SUBJECT: Request for Quotation # 16-0105-DS

Ellenton Gillette Road Directional Drill Automated Traffic

Management System (ATMS) Conduit (Phase 1)

ADDENDUM # 1

TYPICAL SECTION SR 1-275 NTS

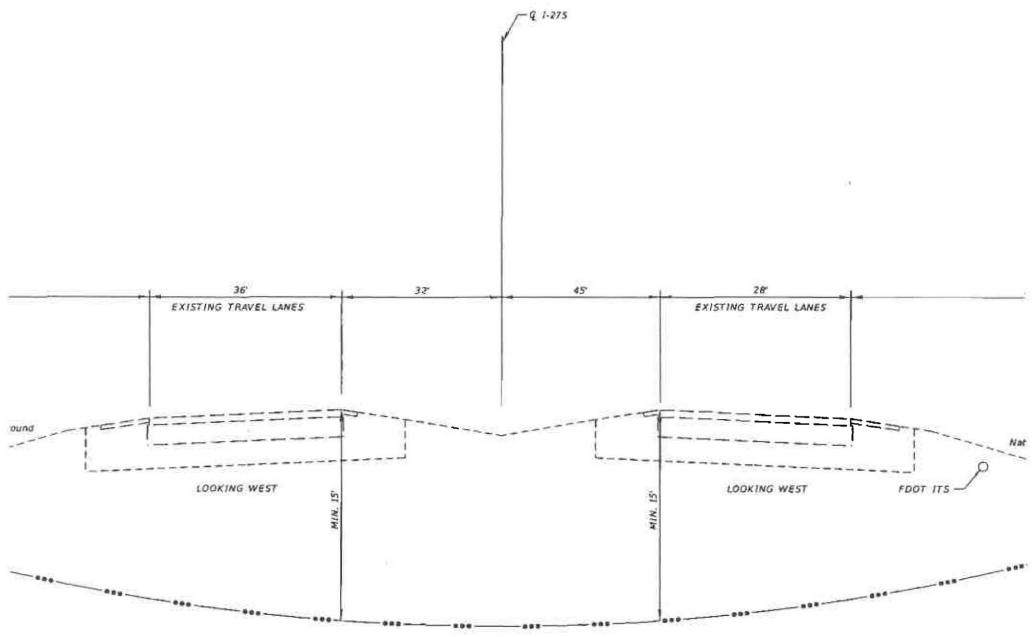
Question # 2: Reference plan sheet "Typical Section" SR I-275, this drawing shows

installing (1) 6" directional bore pipe with (2) 2" conduits, are we to include the 2-inch conduits in our bid? Are these two (2) 2-inch conduits being

installed inside the 6-inch directional drilled pipe?

- Response # 2: No, the project is to install 2 2 inch HDPE conduits for future ATMS needs. The 6" is for the back reamer with the two (2) 2" conduits.

- Response #8: Not Applicable. The 6" is for the back reamer with the two (2) 2" conduits
